**TOWN OF NEWBURGH  
PLANNING BOARD  
TECHNICAL REVIEW COMMENTS**

**PROJECT: U.S. CRANE & RIGGING**  
**PROJECT NO.: 2016-14**  
**PROJECT LOCATION: SECTION 97, BLOCK 1, LOT 21.2**  
**REVIEW DATE: 15 MAY 2017**  
**MEETING DATE: 18 MAY 2017**  
**PROJECT REPRESENTATIVE: MASER CONSULTING**

# SITE PLAN FOR 18 ROUTE 17K, LLC SECTION 97, BLOCK 1, LOT 21.2 TOWN OF NEWBURGH COUNTY OF ORANGE, STATE OF NEW YORK,

**WET TAP DETAIL**  
N.T.S.

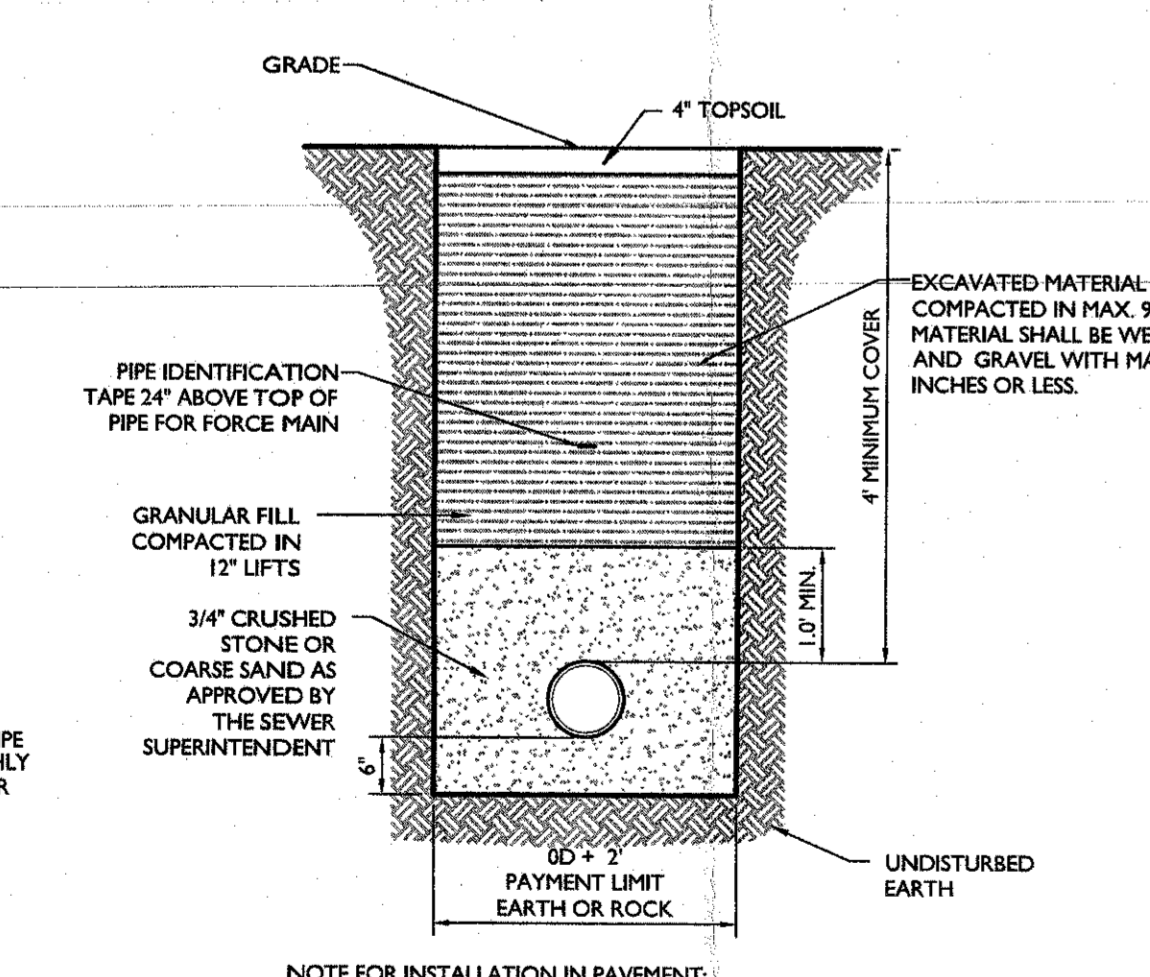
Comment 10. The Water Main Wet Tap detail identifies thrust blocks to be utilized. Town of Newburgh requires all piping be restrain joint pipe without the use of thrust blocks.

Response 10. Thrust blocks have been removed from the detail.
